## Determination 2011/095

### Regarding the code-compliance of a channel drain around the foundation of a house and garage at 533 Waitoki Road, Wainui, Auckland

**Figure 1: Section of the channel drain-as built (as provided by the applicants)**

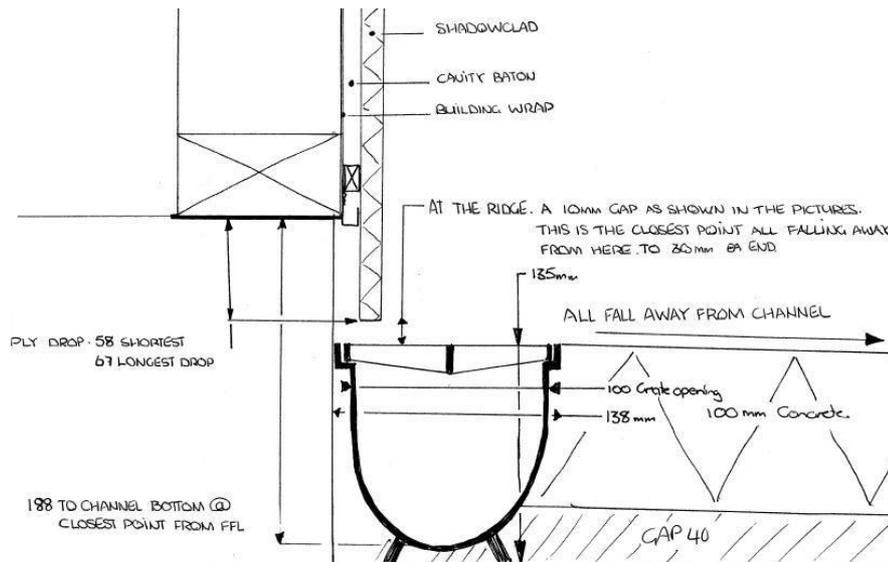
- 2.6 A proprietary black plastic channel drain has been installed along the rear elevations of the house, and around three sides of the garage. The channel drain is made from black polypropylene and is 138mm wide by 135mm deep with a removable grate. The grate has an open area of approximately 60%. Figure 1 shows the channel drain as installed.

- 3.4 In addition the authority described its concerns about the drain as follows:
- the drain in terms of length, fall, capacity and where it discharged

- the possibility that surface water can flow into the drain because the concrete paving did not have fall away from the drain
  - the cladding was 'sitting hard against the grating ... and may make [its] removal for maintenance difficult'.

- 5.3 The expert further noted that the top of the concrete paving is generally around 70-100mm below the floor slab and noted that the plywood cladding extends 60-70mm below the cavity closure. The bottom of the channel drain was 120-140mm below the bottom edge of the plywood cladding.

- 5.4 The expert noted that the plywood cladding terminates ‘very close to the [grate of the channel drain] in places’ which raised the possibility of water hitting and bouncing up off the grill and hitting the bottom edge of the plywood cladding. The expert observed, in at least one instance, that the bottom edge of the plywood was not protected by a coating system. The expert was of the opinion that if the edge was not protected ‘water may soak into the plywood in sufficient quantities to cause premature deterioration of the cladding’, and that the effect of water ingress on the bottom plate should also be considered.

6.4.6 The clearance from the concrete floor to the concrete paving adjacent to the cladding is between 70-100mm. The clearance from the concrete floor to the bottom of the channel drain at its highest point is 180mm. The clearance from the bottom edge of the cladding to the bottom of the channel drain directly below the cladding is 120-140mm. The paved surfaces fall away from the building.

6.4.7 The grate to the channel drain has an open area of 60%, and the grating itself has rounded top surfaces. I do not consider the amount of water likely to hit the grate and splash up is sufficient to adversely affect the adjacent building elements.

- 6.5.1 I consider that the channel drain is installed in a manner that does not compromise the building's compliance with Clause E2.3.2. However, I accept the expert's opinion that the clearance from the cladding to the channel drain is minimal at some locations and that these lesser clearances should be increased by trimming back the cladding, corner battens, and similar; and sealing the unpainted bottom edges of these elements: I note the 35mm minimum clearance shown in Figure 18 of E2/AS1 may be used for guidance in this respect. I consider this work is necessary to ensure the building's ongoing compliance with Clause B2 Durability insofar as it relates to Clause E2 External moisture.

- 6.5.2 I acknowledge that the channel drain will require regular inspection and maintenance so that it remains clear of debris, but the performance of the drain is readily observable. I suggest that the end of the channel drain that discharges by the timber deck be extended, so that the discharge point is extended beyond the outer edge of the deck.
